JOINT REGIONAL PLANNING PANEL (Sydney East Region)

JRPP No	2015SYE020 DA
DA Number	DA-605/2014
Local Government Area	City of Canterbury
Proposed Development	Demolition of existing structures and construction of 2 x six storey mixed use buildings, with 5,973m² of retail/commercial space, 297 residential units over 5 levels and 3 levels of basement car parking accommodating 684 car parking spaces
Street Address	1586-1598, 1600-1602, 1604 and 1606 Canterbury Rd, Punchbowl (commonly known as 1600 Canterbury Rd, Punchbowl)
Applicant / Owner	Urbanlink P/L
Number of Submissions	Nil
Recommendation	Approval with Conditions
Report by	Spiro Stavis - Director, City Planning

Assessment Report and Recommendation

[1] Building Height

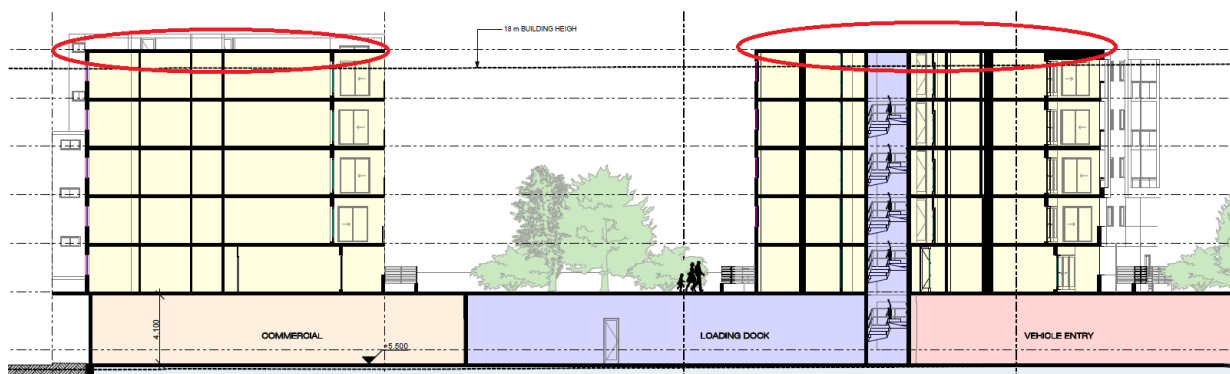
The proposal development seeks a variation to Clause 4.3(2) relating to the maximum height of buildings. The diagram below illustrates that part of the proposed building which exceeds the 18m building height limit (shown by a faint black dashed line within the top storey). The building's roof slab will encroach beyond the 18m limit by between 1.41m and 2.14m. The diagrams below shows a side cross section of the proposed development and the extent of non-compliance.

Comment: Compliance with our Building Height standard is unreasonable in this instance as the excess height of the proposal relates to the site being flood affected. The construction of the ground floor at RL6.3 provides for 500mm of freeboard above the 1:100 year ARI. The building would otherwise comply with the maximum height requirements of the CLEP 2012.

Block A and B

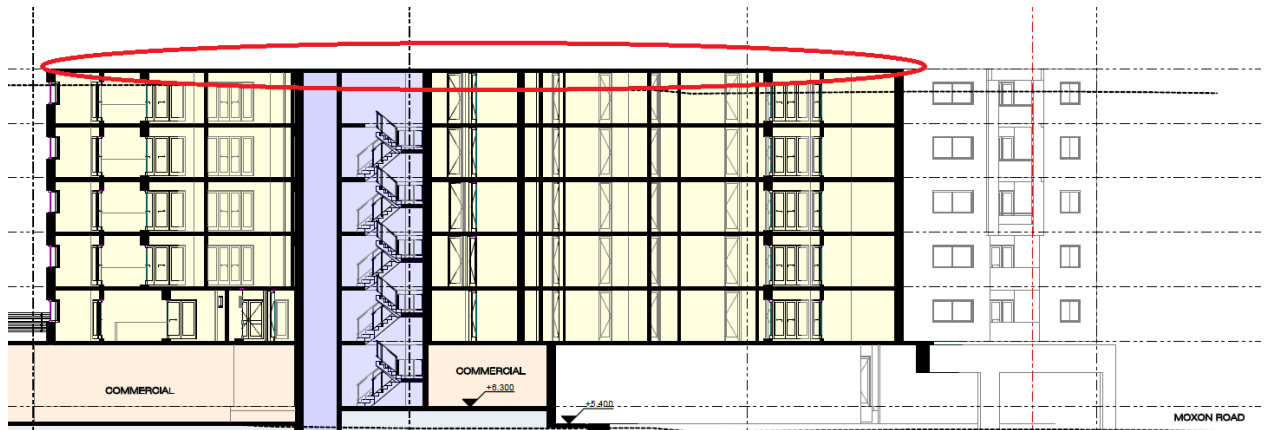
The diagram below shows in plan form the extent of non-compliance (clouded in red).
